**ADDENDUM NO. 2**

DATE: January 31, 2024

PROJECT: Benton Washington Regional Public Water Authority
Phase 1A – Water Treatment Plant Improvements – High Service Pump Station
Rogers, ArkansasBID DATE: February 21, 2024 at 2:00PM

JOB NO.
2124
SHEET NO.
C13

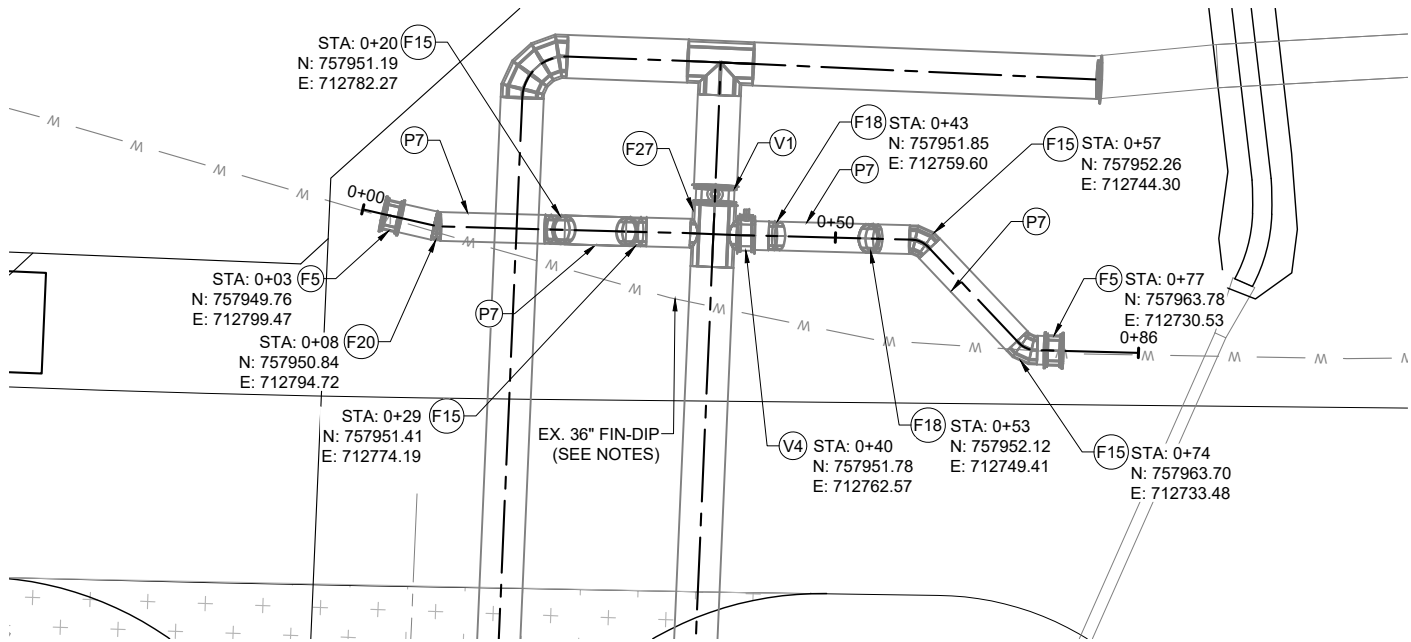
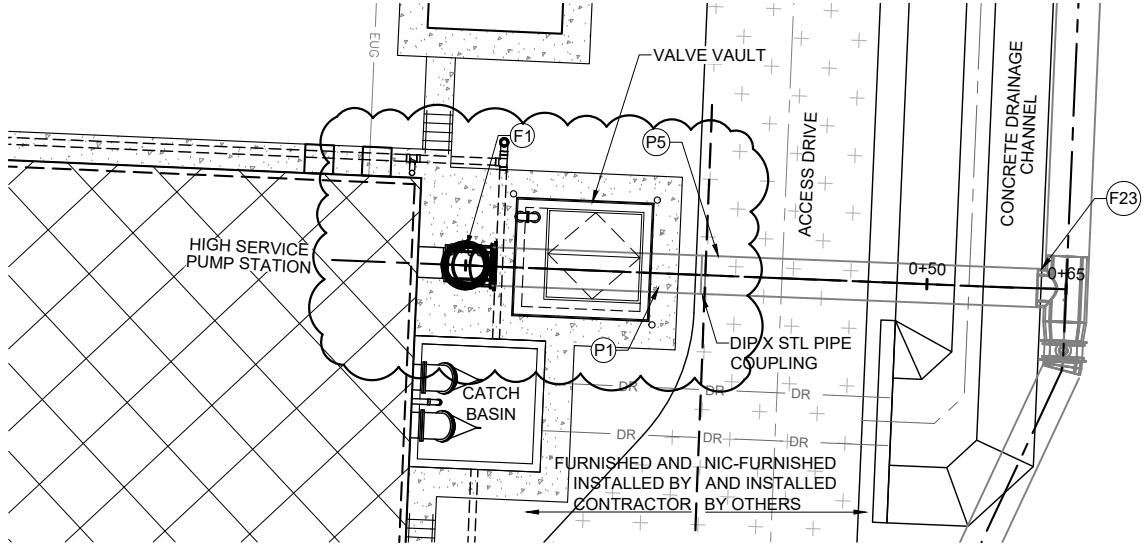
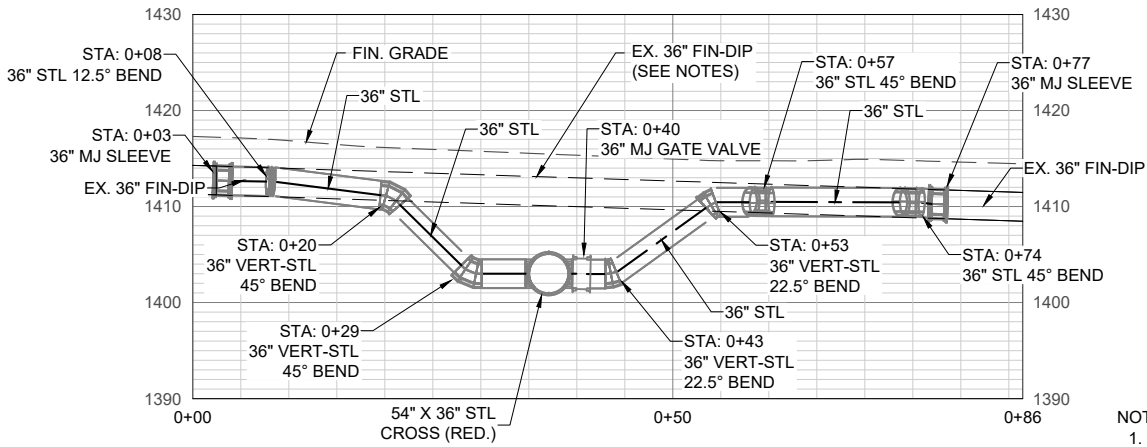
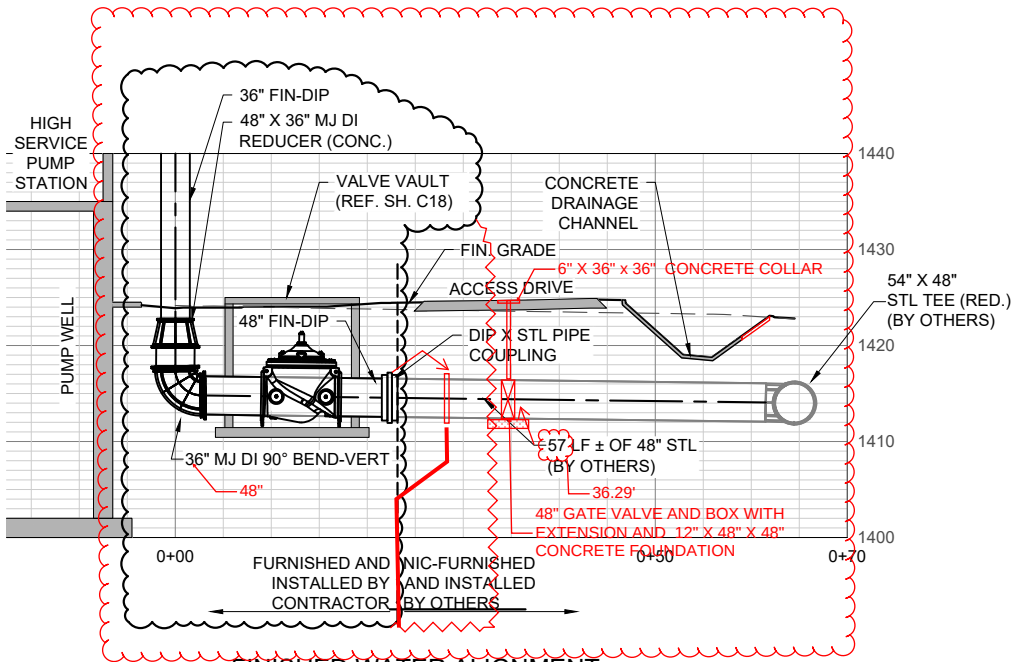
REV. NO.	DATE	DRWN	CHKD	REMARKS
1	1-31-24	CEI	JDM	ADDENDUM NO. 2, ADD 48" GATE VALVE AND COLLAR

JOB NO.
2124
SHEET NO.
C14

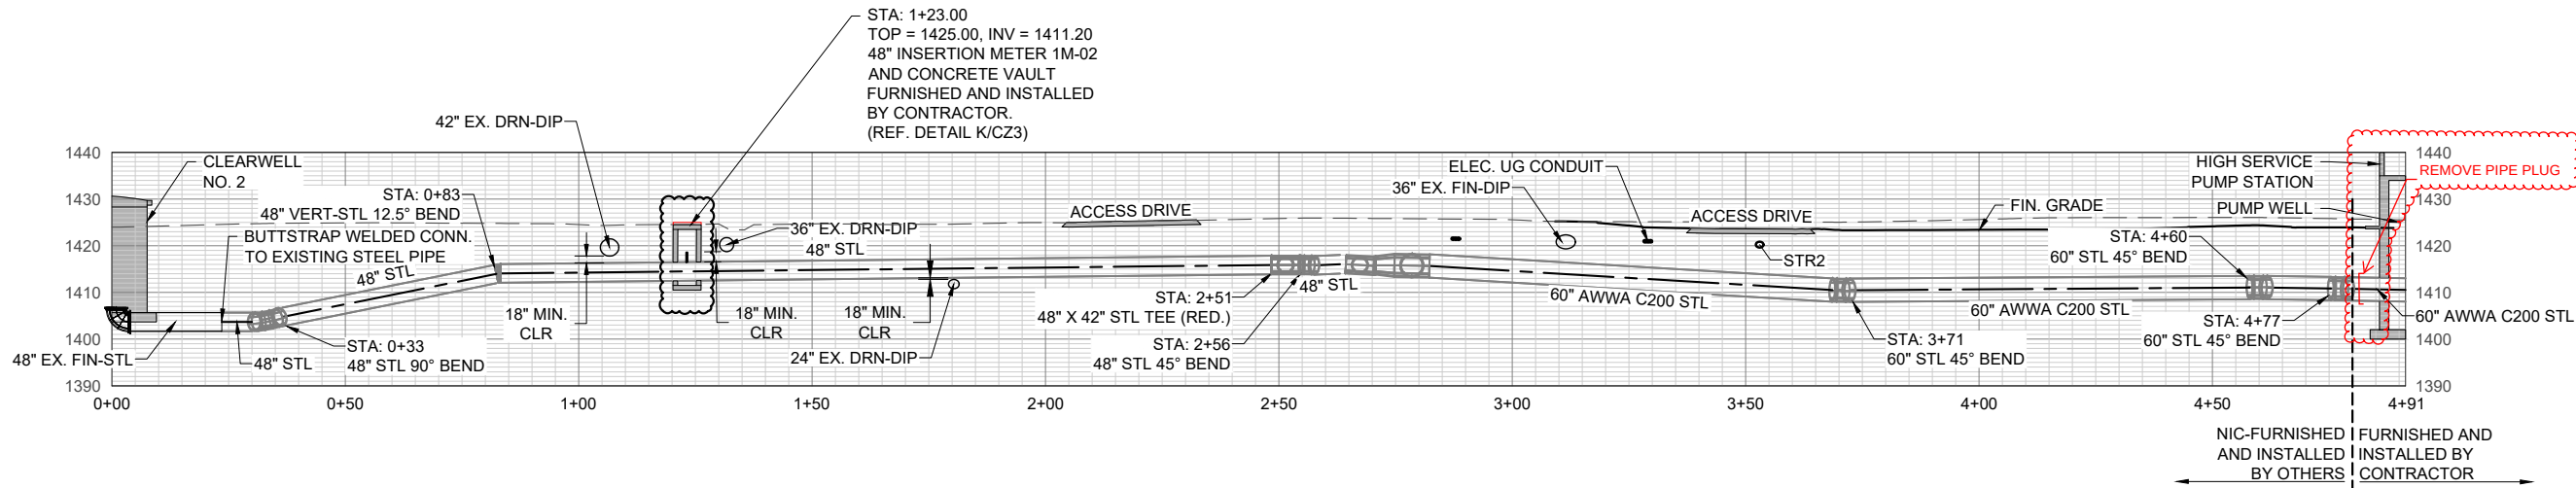
REV. NO.	DATE	DRWN	CHKD	REMARKS
1	1-31-24	CEI	JDM	ADDENDUM NO. 2, PIPE PLUG NOTE ADDED

JOB NO.	2124
SHEET NO.	C15

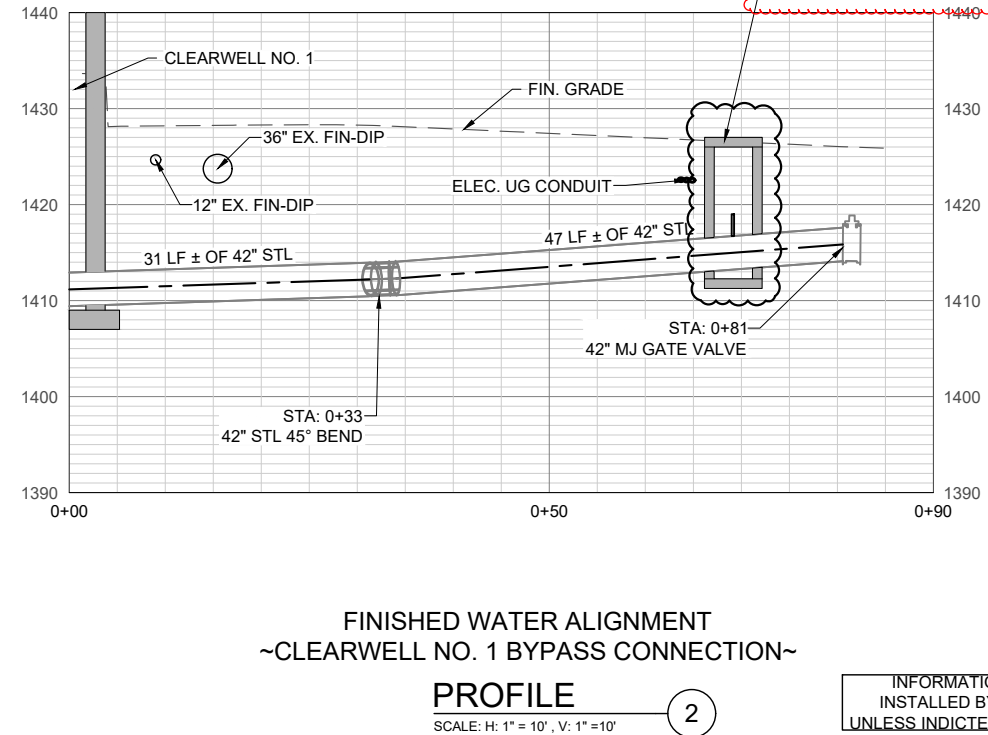
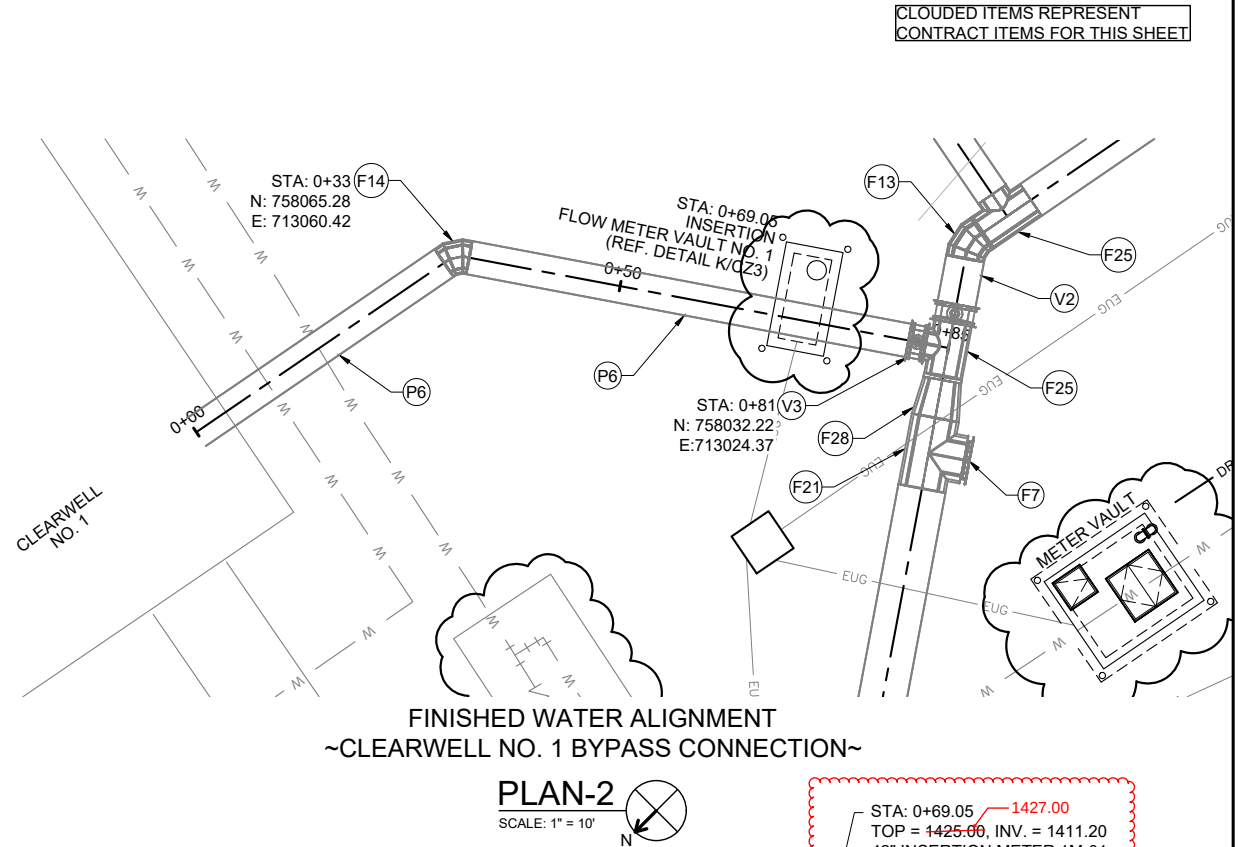
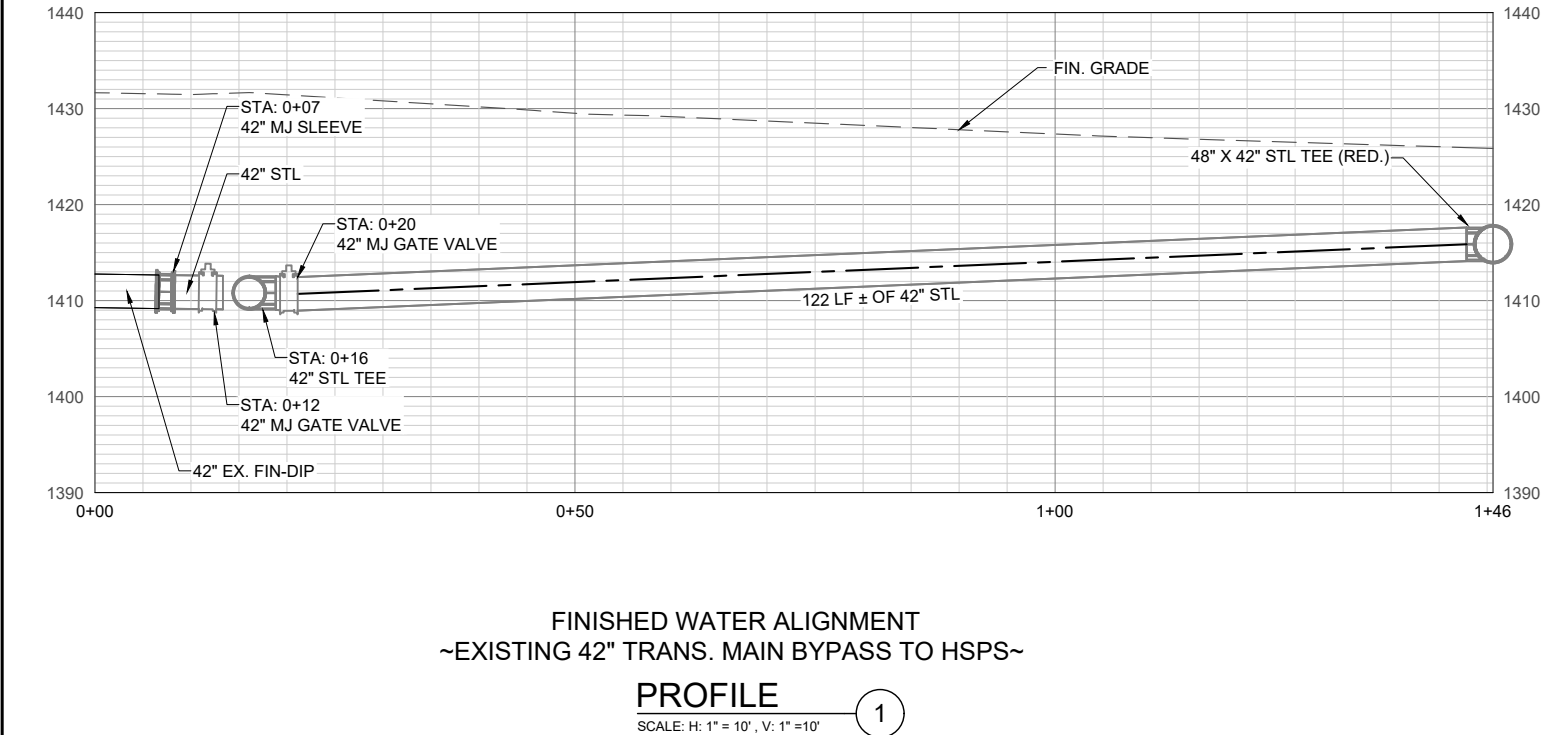
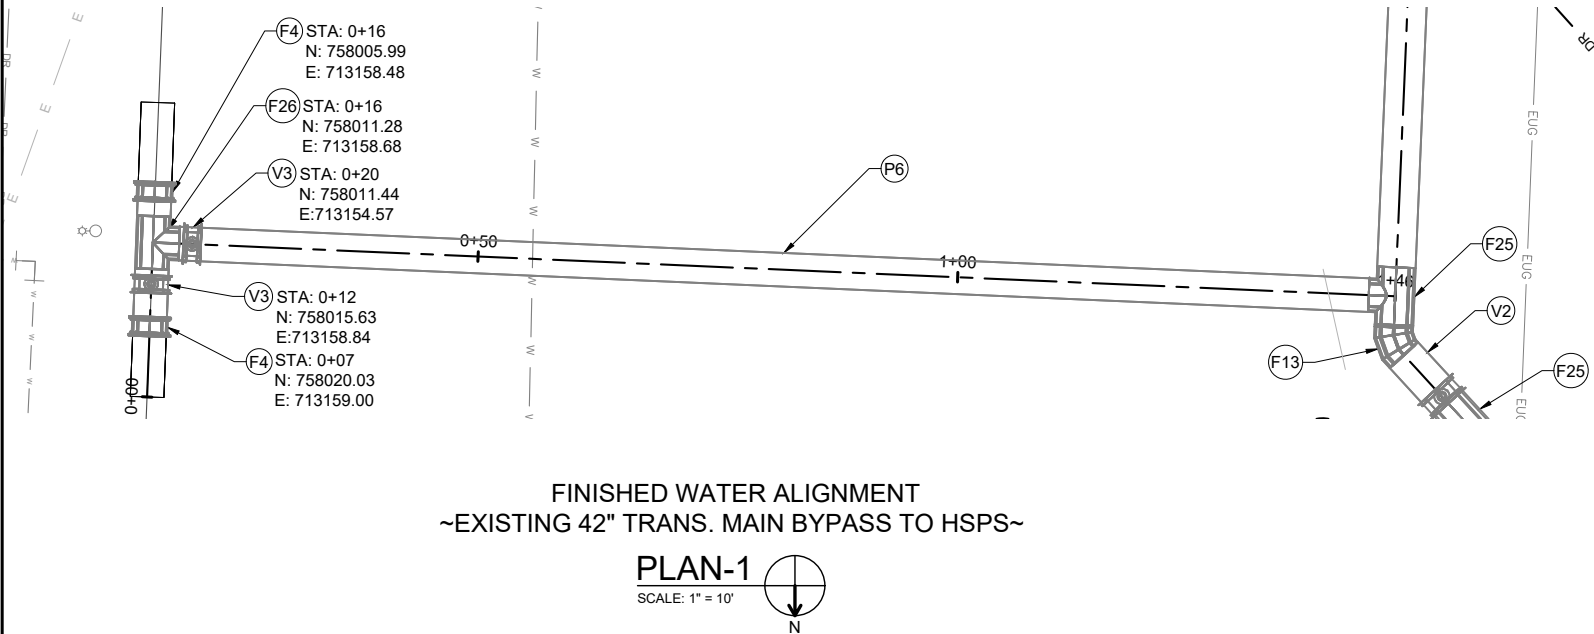
REV. NO.	DATE	DRWN	CHKD	REMARKS
1	1-31-24	CEI	JDM	ADDENDUM NO. 2, MODIFIED INSERTION METER VAULT TOP ELEVATION.

STA: 0+69.05
TOP = 1425.00, INV. = 1411.20
42" INSERTION METER 1M-01
AND CONCRETE VAULT
FRUNISHED AND INSTALLED
BY CONTRACTOR
(REF. DETAIL K/CZ3)

JOB NO:
2124
SHEET NO:
B3

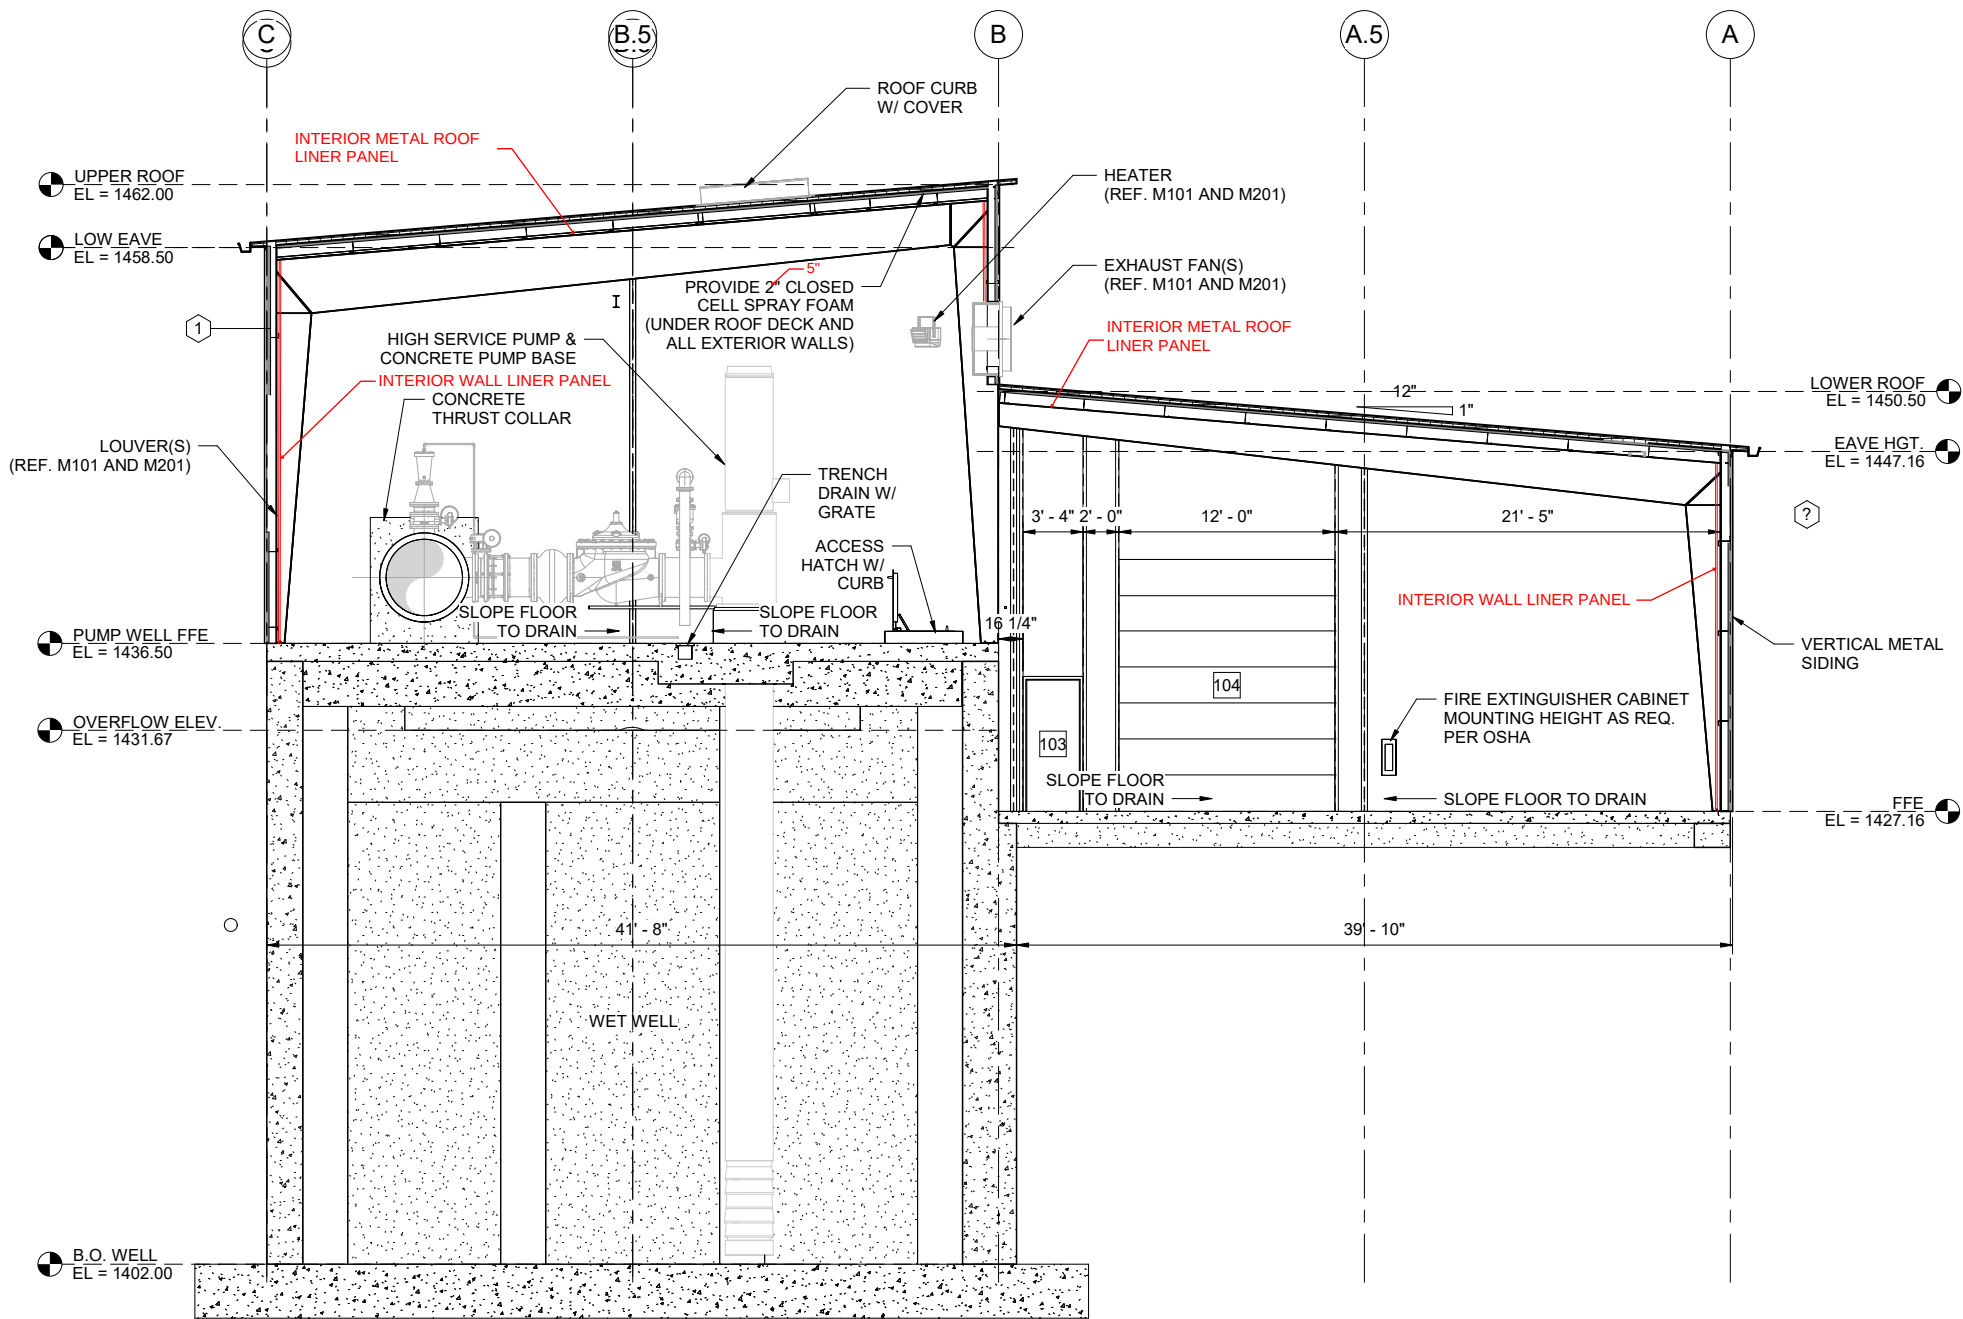
REV. NO.	DATE	DRWN	CHKD	REMARKS
1	1-31-24	CEI	JDM	ADDENDUM NO. 2, ADDED INTERIOR BUILDING PANELS
